City of Raymore

ADDENDUM NO. 1

Storm Water Improvements 17-278-201

Addendum No. 1 - Revised Bid Proposal Form E

Headwall Repair - Photo #1

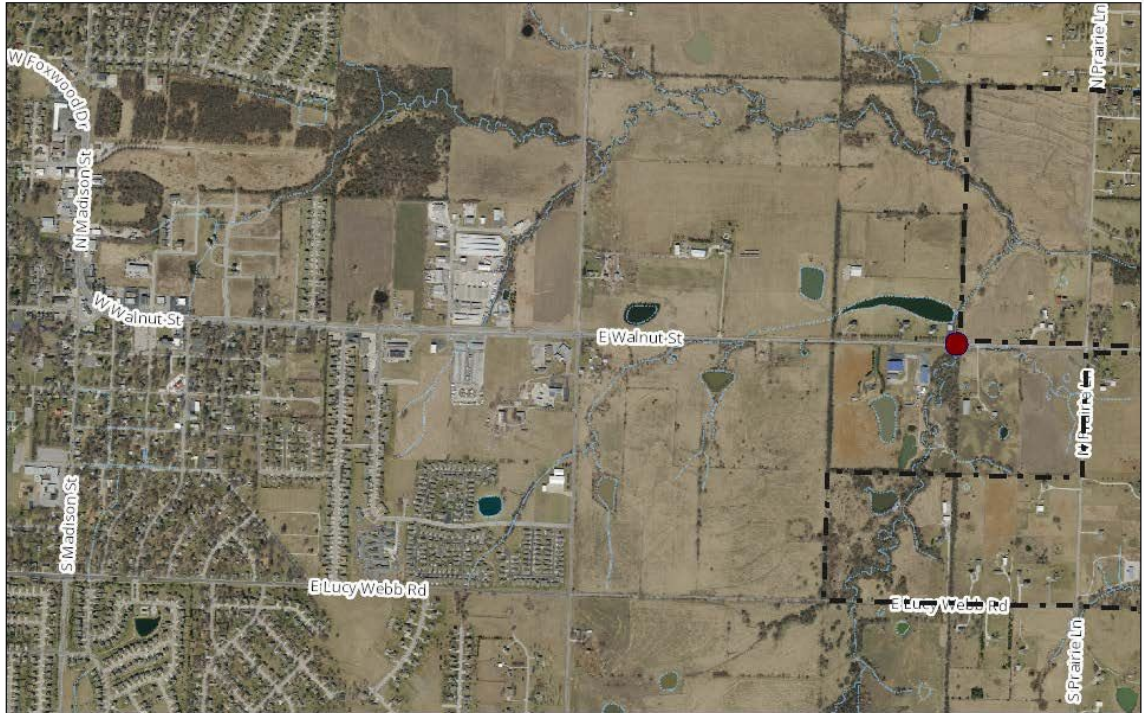
- 2. Headwall Location and Photos - See Attached**
